Application No. 10/617,914
Amendment Dated: December 3, 2004
Reply to Office Action of: September 27, 2004

In the Drawings

FIG. 2

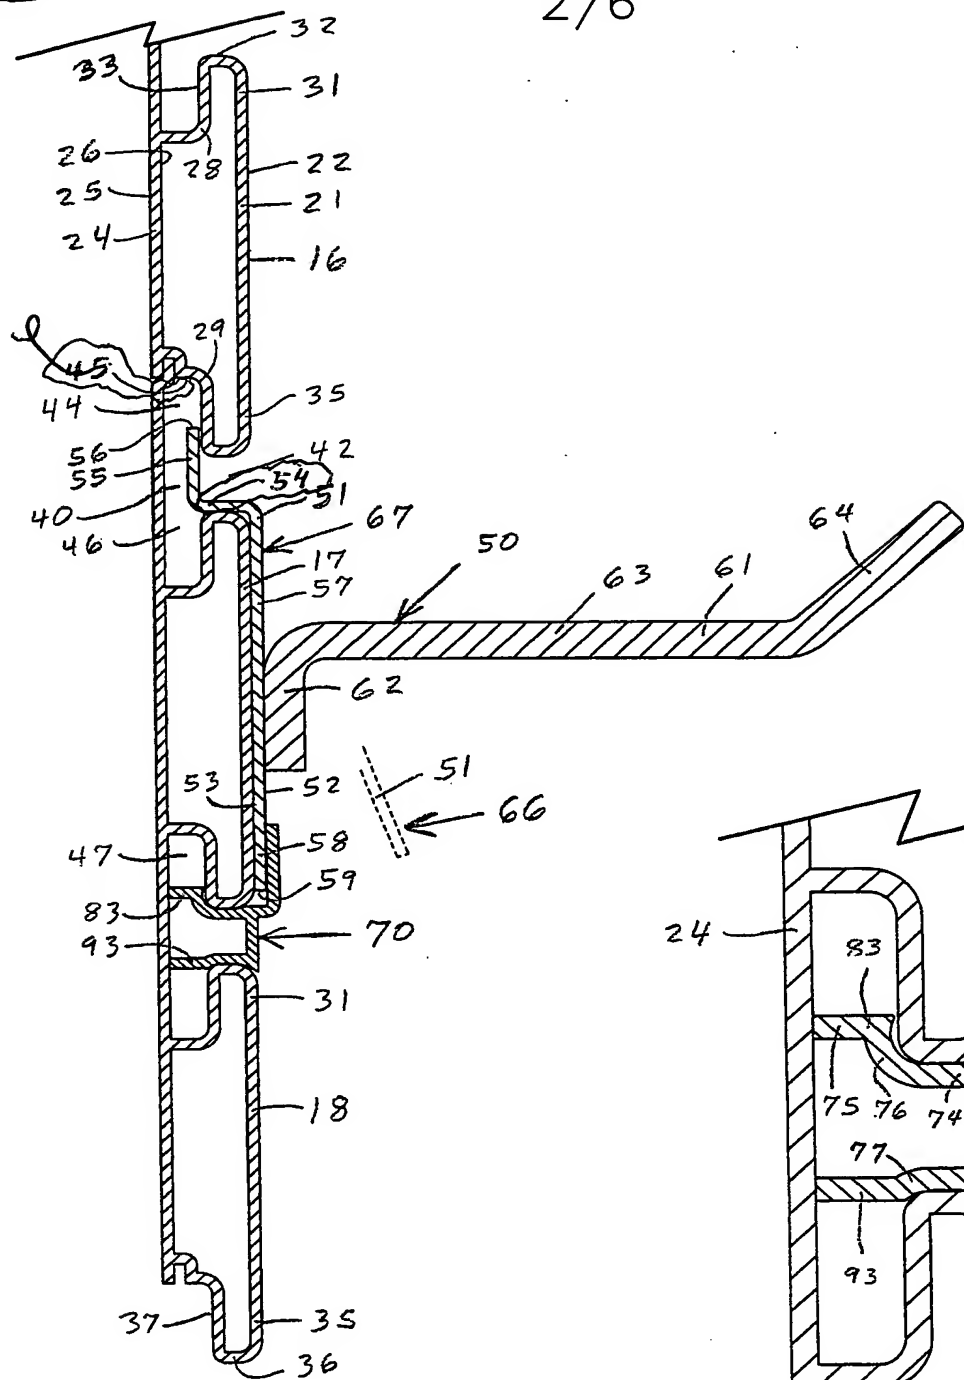
Please amend drawing Figure 2 to delete reference number "45," add reference number "54" and delete the dashed lines showing hanger 51 in tilted position 66.

Please add drawing Figure 2A to more clearly show the hanger 51 in its tilted position 66.
